# CO-DESIGN WORKSHOP SUMMARY

## Merrimu PSP

Client: Victorian Planning Authority (VPA)

15/11/2022

Figure 3-1 BMELR Options A, B and C Concept Based Plan with feedback

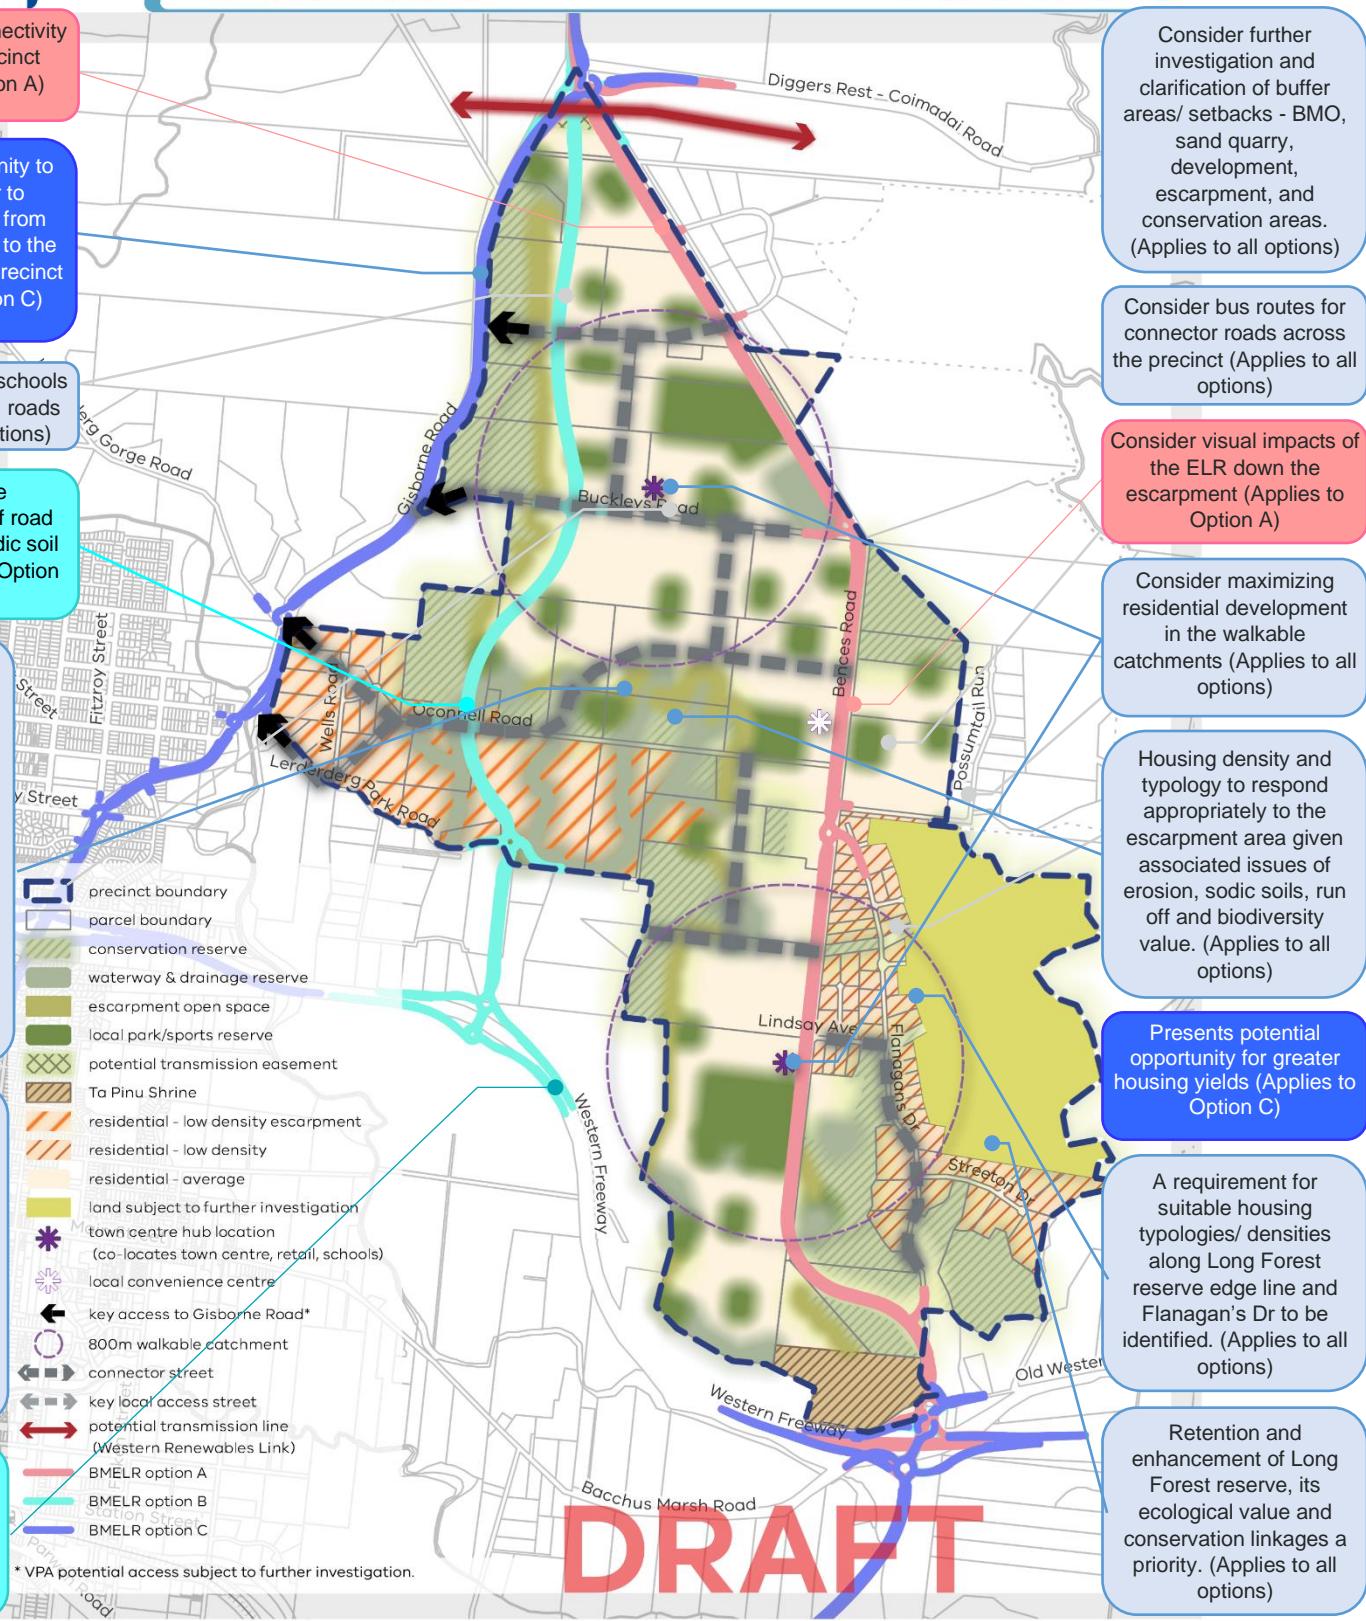
Road network to provide appropriate safety and emergency access—must be able to accommodate for emergency vehicles in bushfire situations (Applies to all options)

Consider bus routes for connector roads across the precinct (Applies to all options)

Consider visual impacts of the ELR down the escarpment (Applies to Option A)

Consider maximizing residential development in the walkable catchments (Applies to all options)

Housing density and typology to respond appropriately to the escarpment area given associated issues of erosion, sodic soils, run off and biodiversity value. (Applies to all options)
